DATE: December 11, 2019

SUBJECT: ADDENDUM #3 TO THE BIDDING DOCUMENTS FOR:  
**BID GROUP #8**  
**MASTER FACILITY PLAN IMPLEMENTATION**  
**COMMUNITY HIGH SCHOOL DISTRICT 99**  
**1436 NORFOLK STREET**  
**DOWNERS GROVE, IL 60516**

This addendum forms a part of the Bidding Contract Documents, dated November 20, 2019. Bidders must acknowledge receipt of this Addendum in the space provided on the Bid Form. Drawing revisions clouded and tagged throughout with delta 39.

**M2.01D.c**

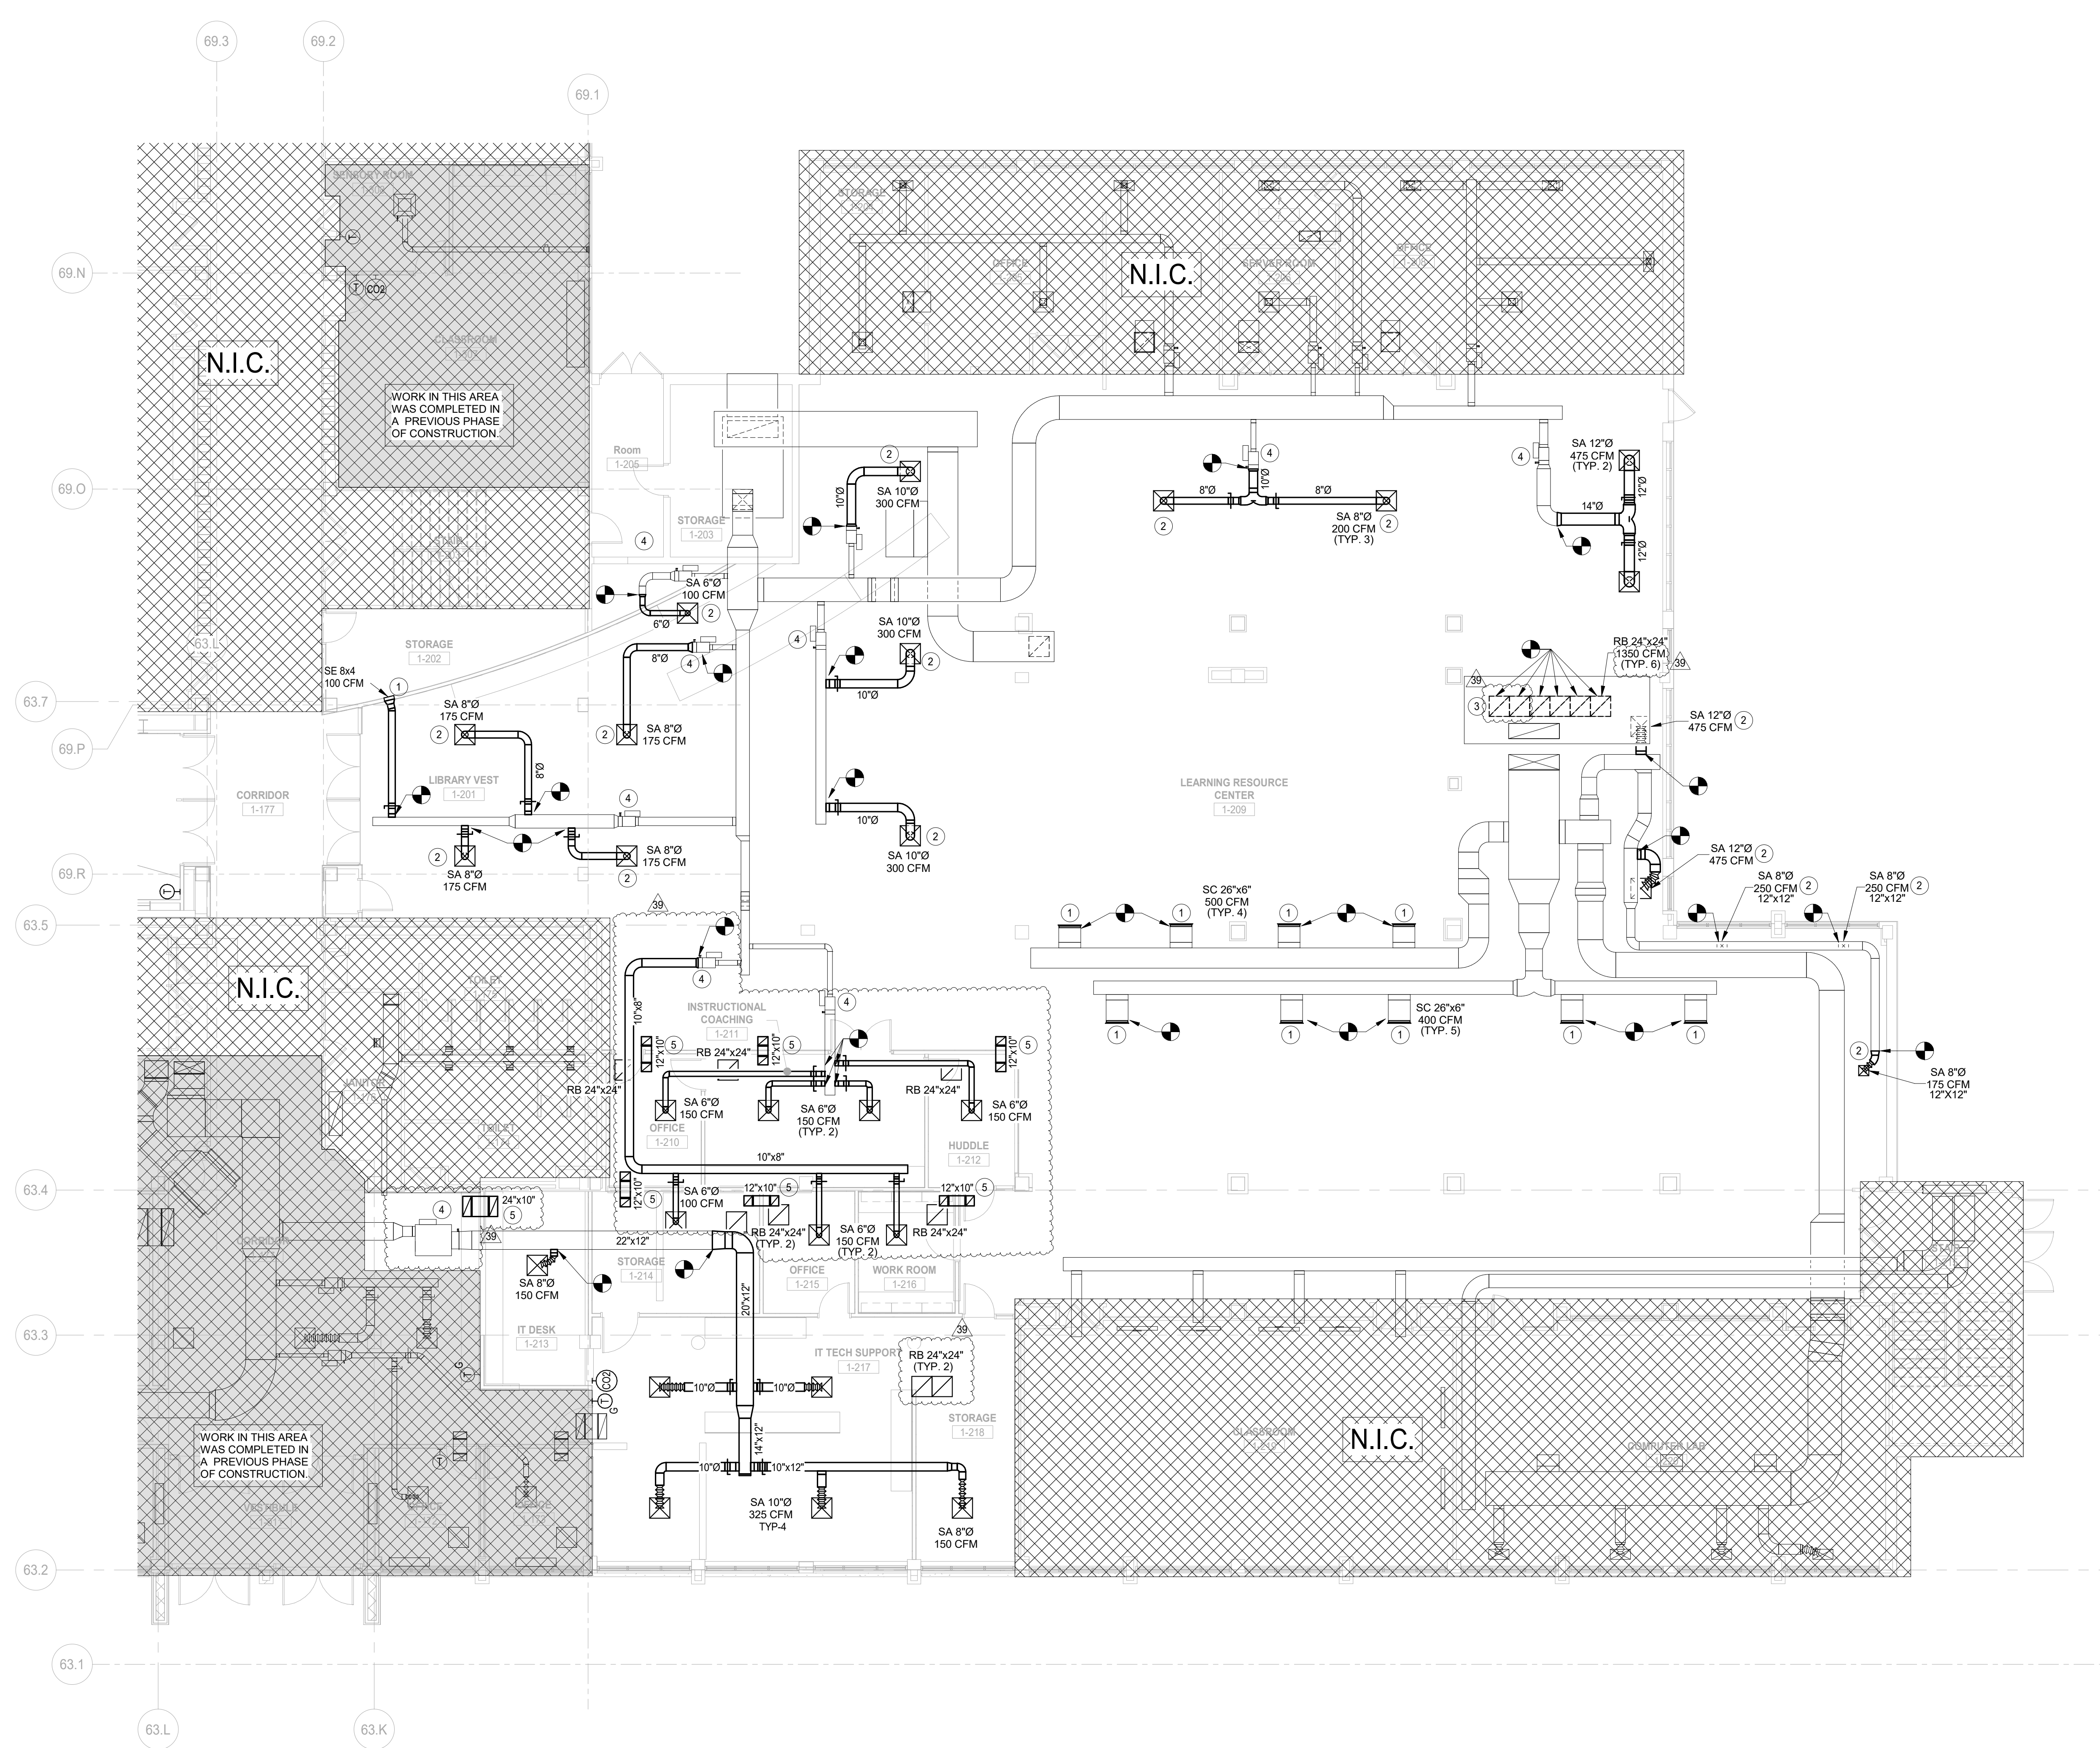
- a. Added sizes of ductwork and tags for diffusers.
5. Sheet M2.01D.c MECHANICAL DUCT FLOOR PLAN LEVEL 1 AREA D (**Full size sheet issued**)
  - a. Added two return diffusers to the learning resource center.

- b. Revised the ductwork layout of the offices.
6. Sheet M2.01F.c MECHANICAL DUCT FLOOR PLAN LEVEL 1 AREA F (**Full size sheet issued**)
  - a. Revised medium pressure ductwork to the VAV boxes.

# M2.01F.c

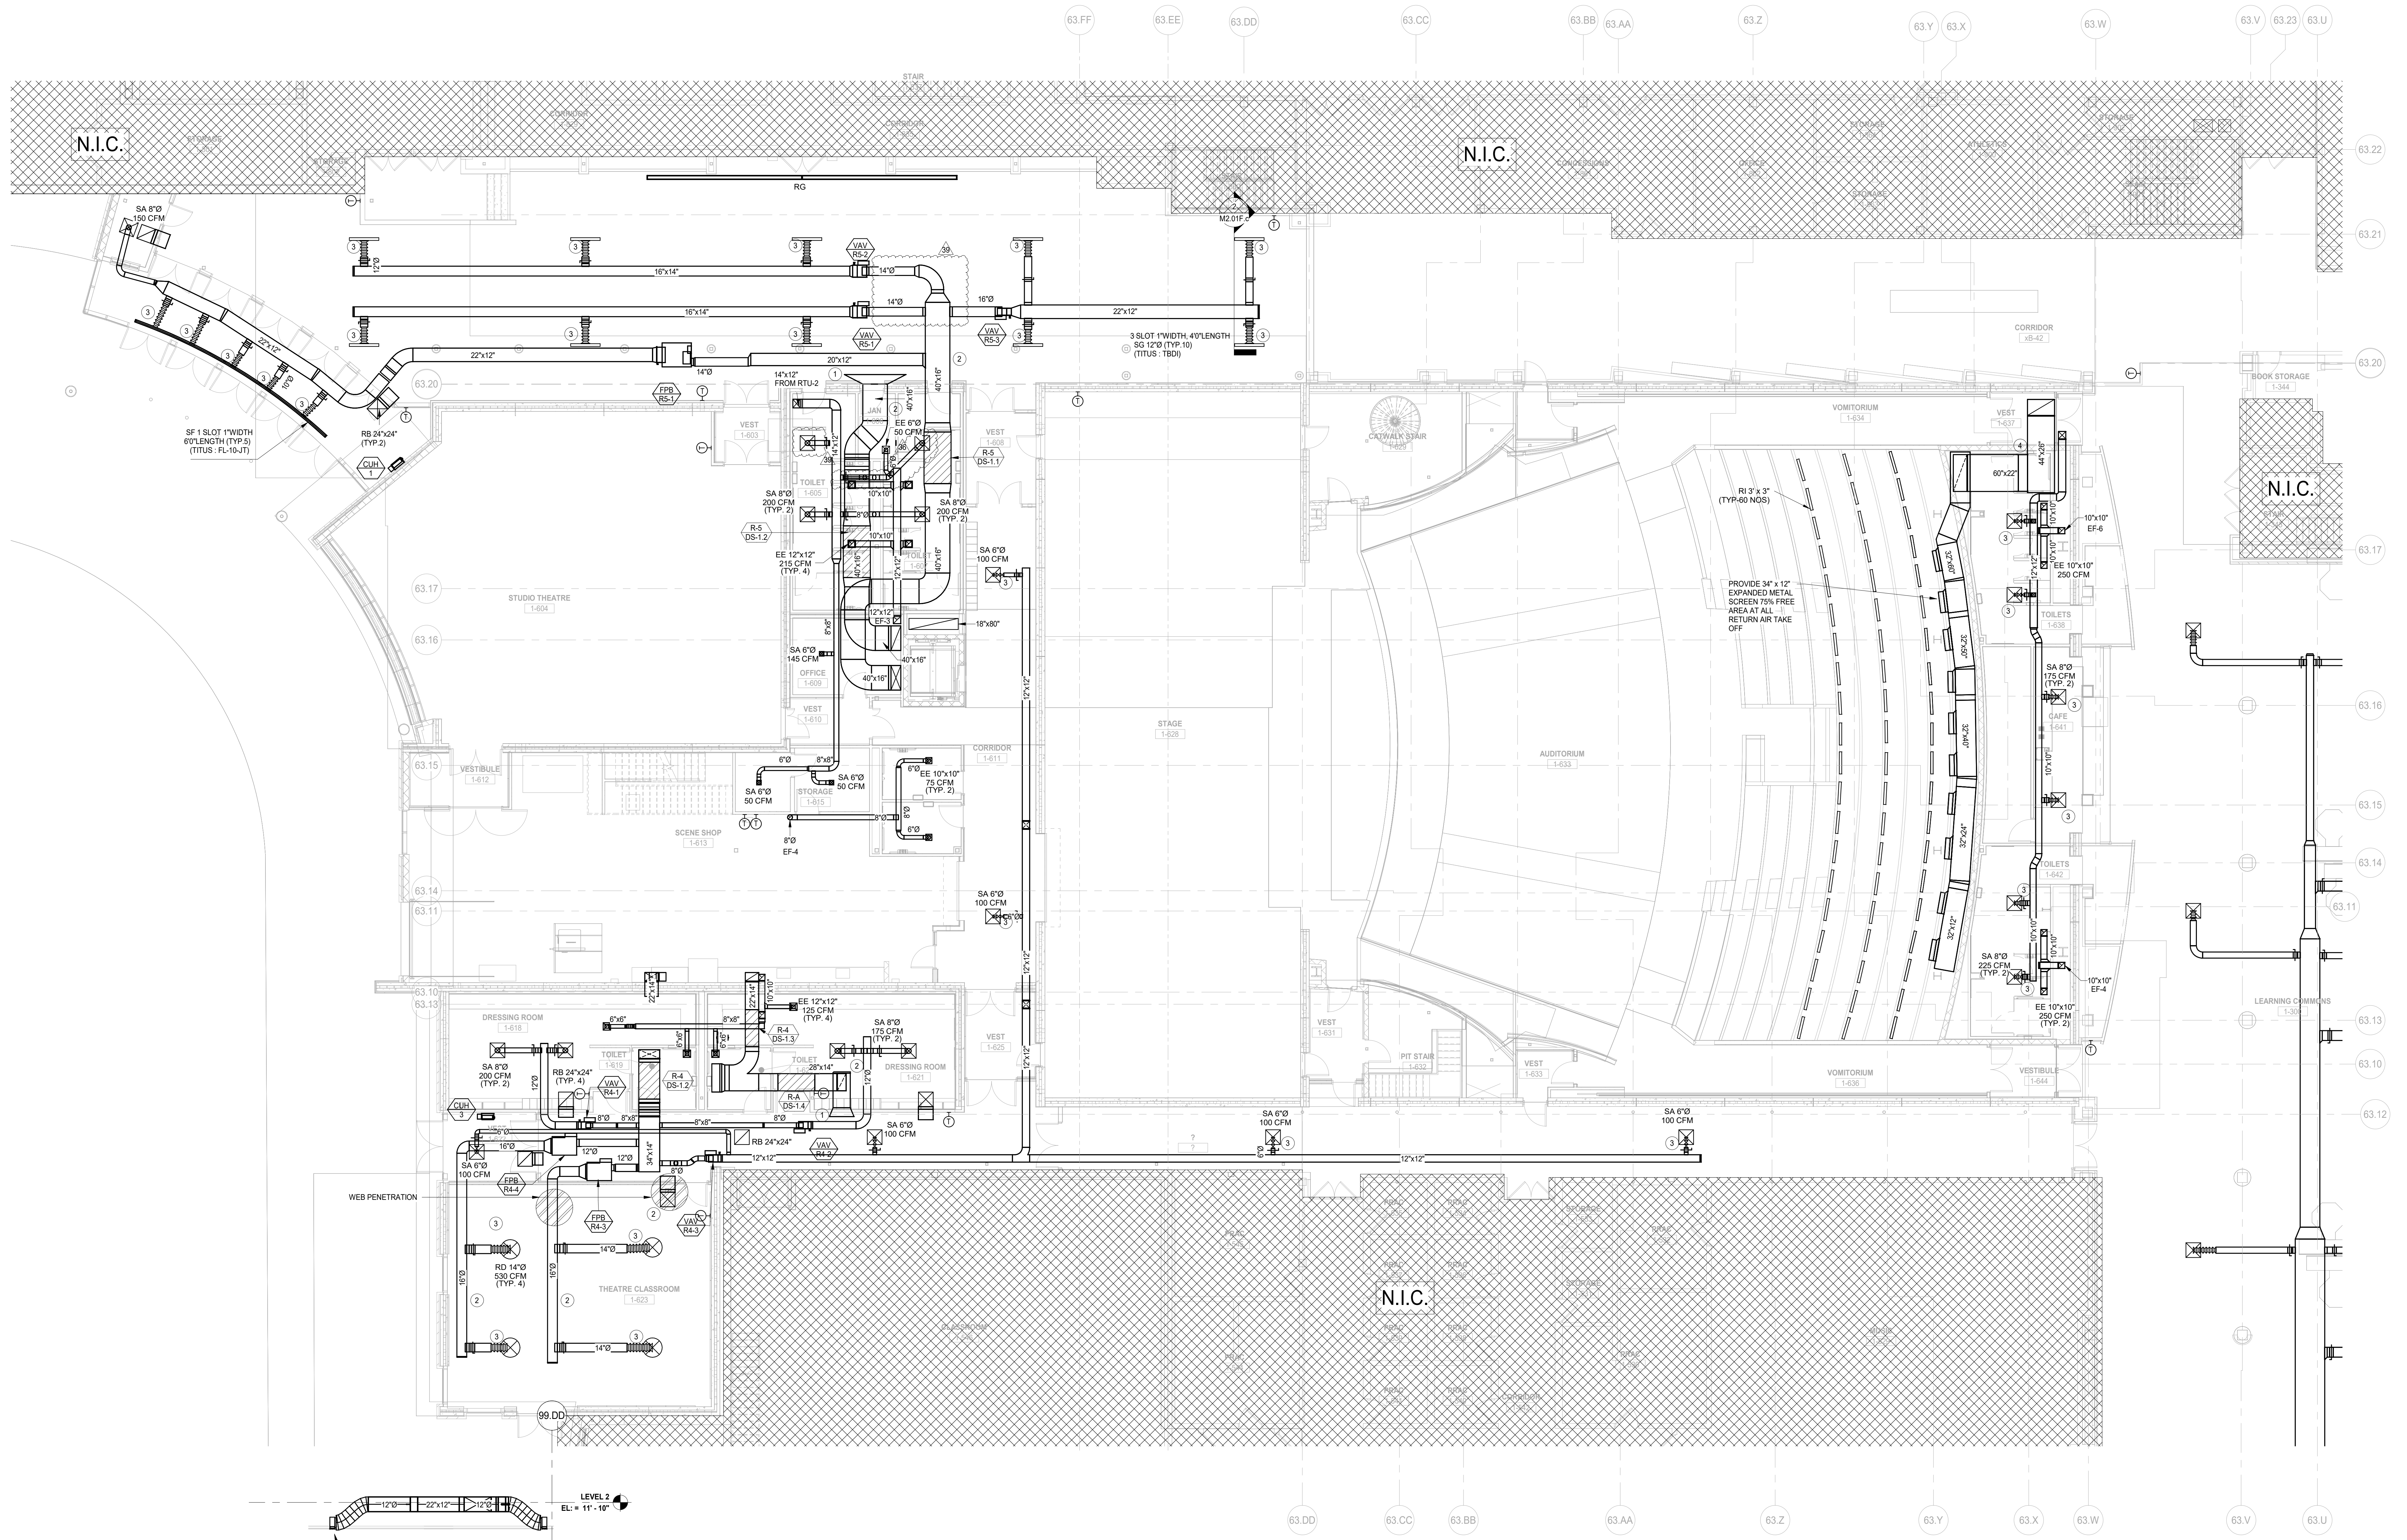
- b. Added two supply diffusers to the toilet areas.
7. Sheet M2.02B.c MECHANICAL DUCT FLOOR PLAN LEVEL 2 AREA B (**Full size sheet issued**)
  - a. Added information for the supply diffusers and the electric duct heater serving reading room and office.

# PD1.11B.c

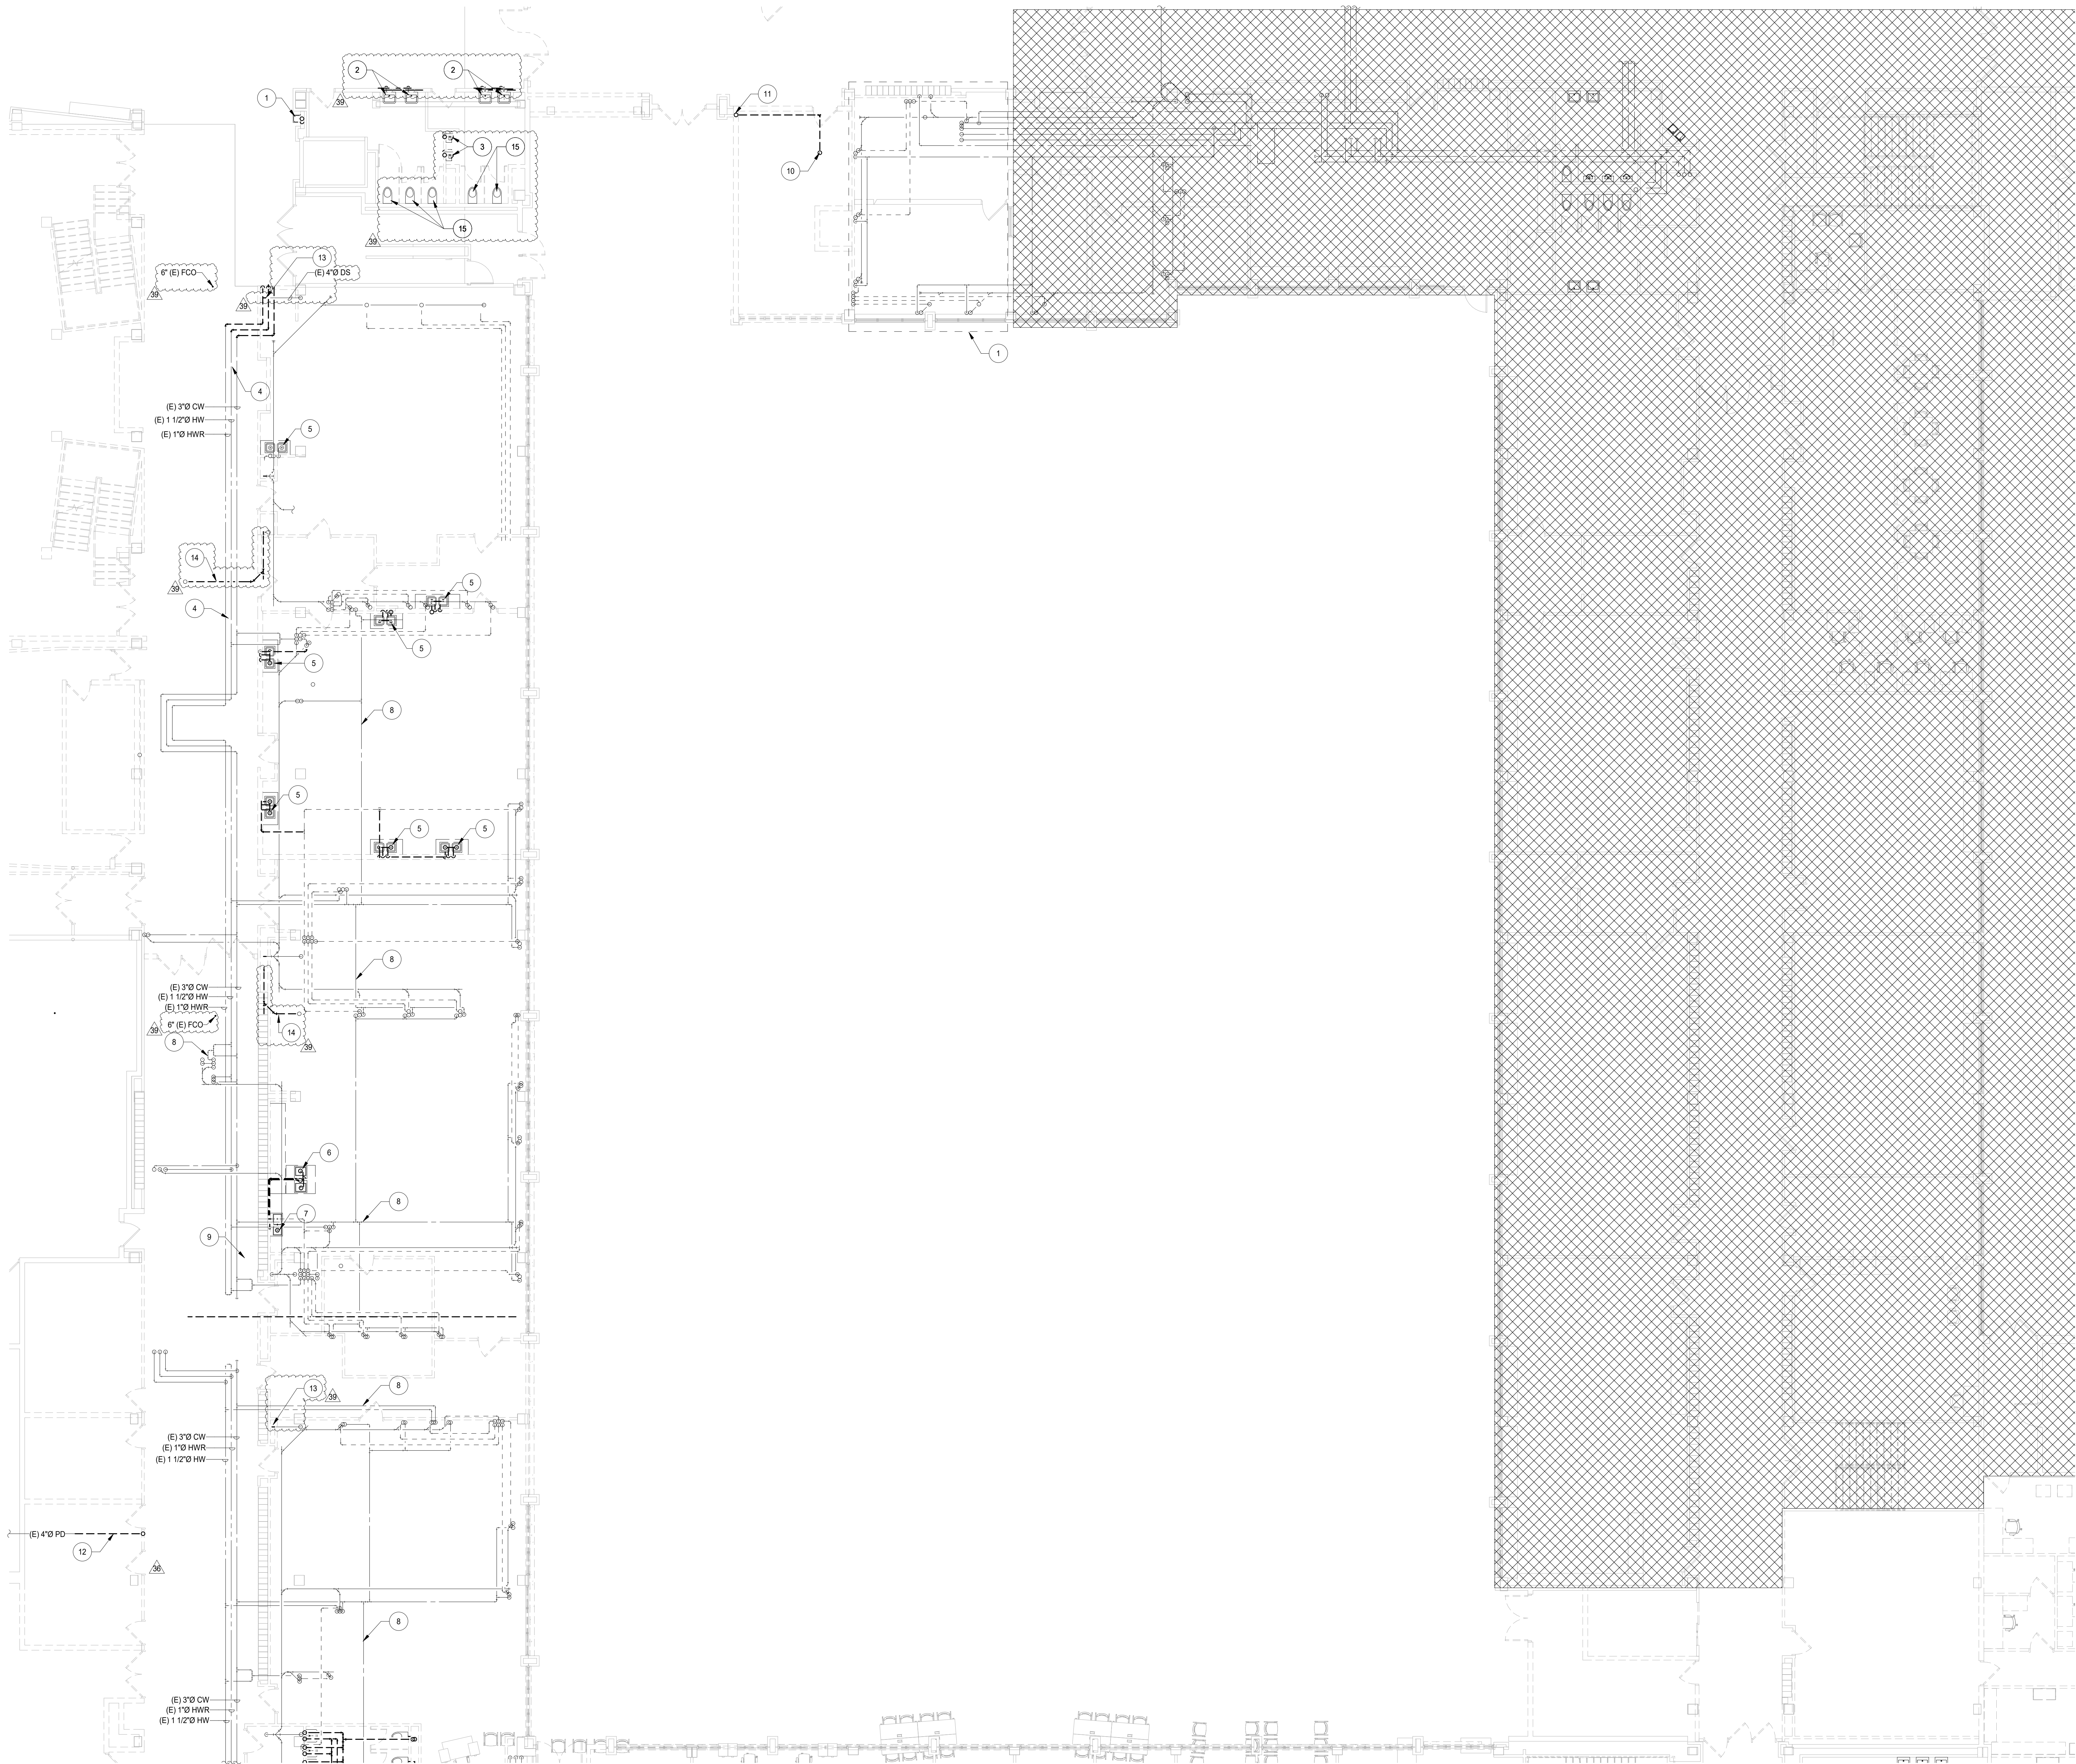
- a. Added demolition of existing suspended downspout piping.
  - b. Added demolition of existing plumbing fixtures.
- 13. Sheet PD1.11F PLUMBING DEMOLITION – LEVEL 1 AREA F **(Full size sheet reissued)**
